# 1969 Corvette: Service News: 1969 Corvette Steering Column - Control Lock Tube Housing Cover Added

**Source:** Chevrolet Service News

**Date:** April 1969 - Volume 41 - Number 4

**Fig. 44—Corvette Control Lock Tube Housing Cover**

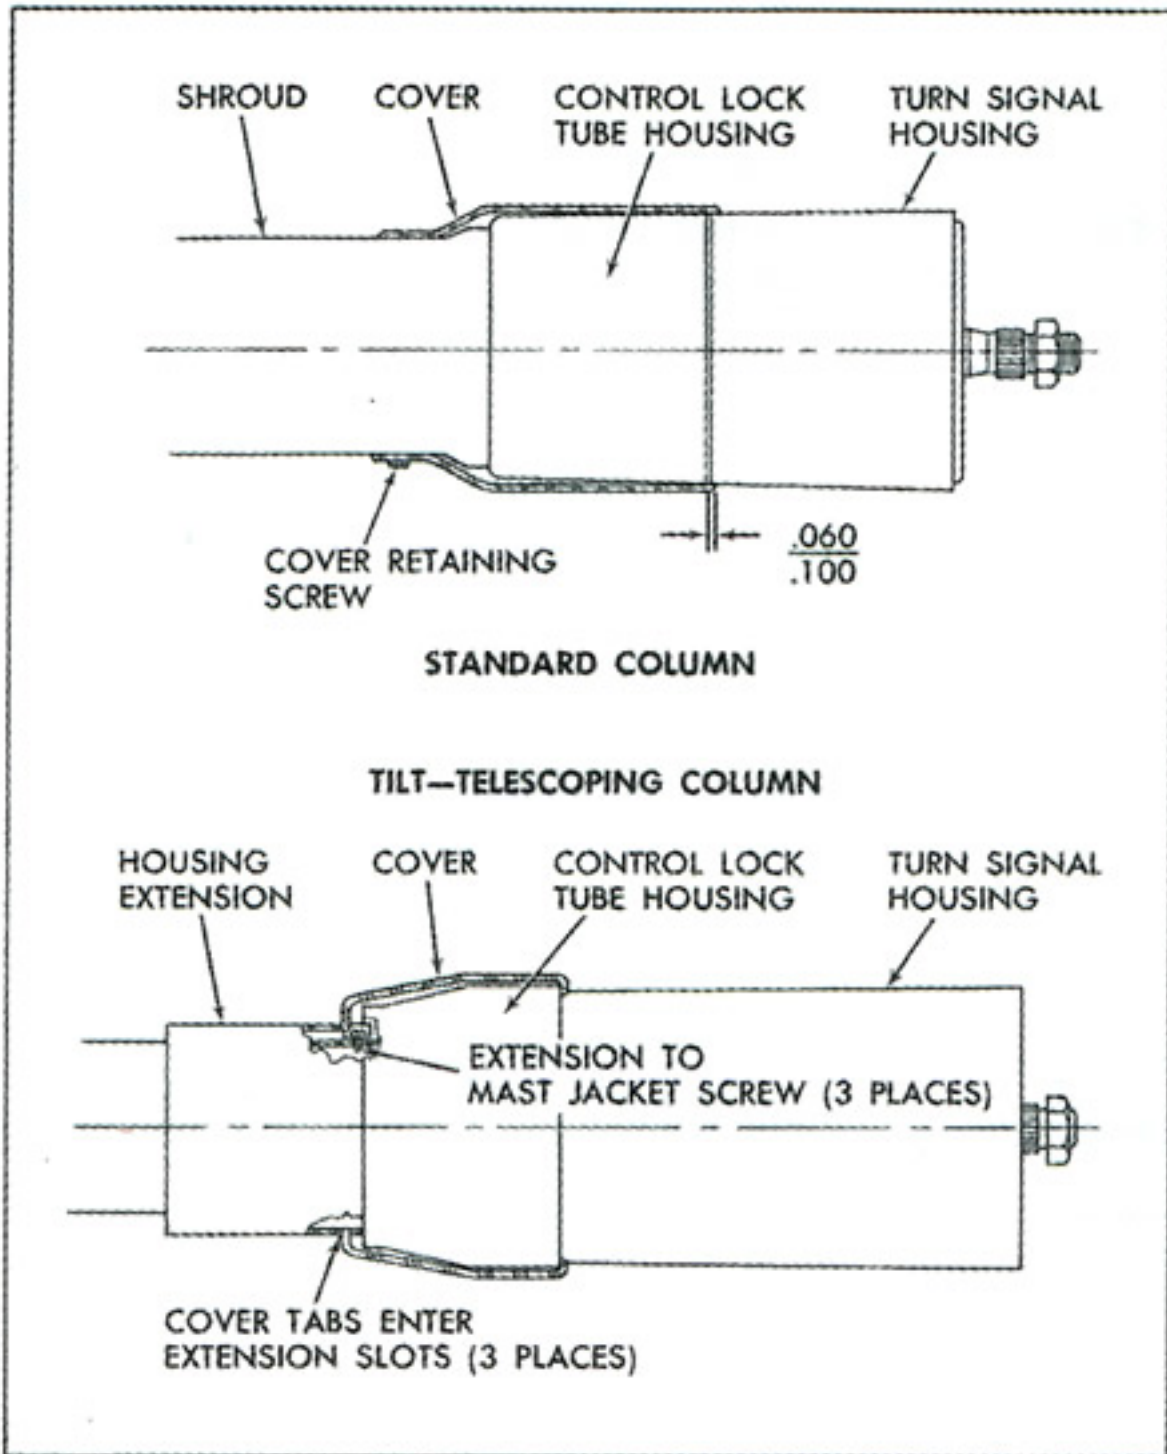
A control lock tube housing cover has recently been incorporated into the 1969 Corvette steering column, both standard and Tilt-Telescoping types, as shown in Figure 44. This cover is intended to prevent the lock tube housing from being rotated and subsequent damage to the control cable.

The following steps in the 1969 Passenger Car Chassis Service Manual should be revised:

On Page 9-14, Step 10 of the procedures for 'Disassembly - All Except Tilt and Tilt-Telescoping Columns; should appear as follows:

10. Remove the gearshift lever housing and shroud from the jacket assembly (transmission control lock tube housing and shroud on floor shift models).

*Corvette* - If either the shroud or housing cover are damaged, remove the retaining screw and slide the cover off the shroud.

On Page 9-17, Step 7 of the procedures for 'Assembly - All Except Tilt and Tilt-Telescoping' should appear as follows:

7. Install the shift tube lock plate and spring into the gearshift lever (or lock tube) housing and install the cover onto the shroud (Corvette). Install the housing and shroud assemblies onto the upper end of the mast jacket. Rotate the housing to be sure it is seated in the bearing.

On Page 9-21, Step 17 of the procedures for 'Disassembly - Tilt and Tilt-Telescoping Columns' should appear as follows:

17. *All Columns* - Remove the shift lever housing from the mast jacket (transmission control lock tube housing on floor shift models). Remove the shift lever spring by winding the spring up with pliers and pulling it out. on floor shift models, remove the spring plunger.

*Tilt-Telescoping Columns* - Pry the transmission control lock tube housing cover tabs out of the slots in the housing extension and remove the cover. Remove the three housing extension screws and remove the housing extension.

On Page 9-22, Step 2 of the procedures for 'Assembly - Tilt and Tilt-Telescoping Columns' should appear as follows:

2. *All Columns* - Install the shift lever spring into the housing by winding it up with pliers and pushing it into the housing. On floor shift models, install the plunger.

*Tilt-Columns* - Slide the gearshift lever housing onto the mast jacket.

*Tilt-Telescoping Columns* - Install the transmission control lock tube housing extension and torque the screws to **40 in. lbs** . Install the housing cover onto the extension. Install the housing onto the mast jacket assembly.
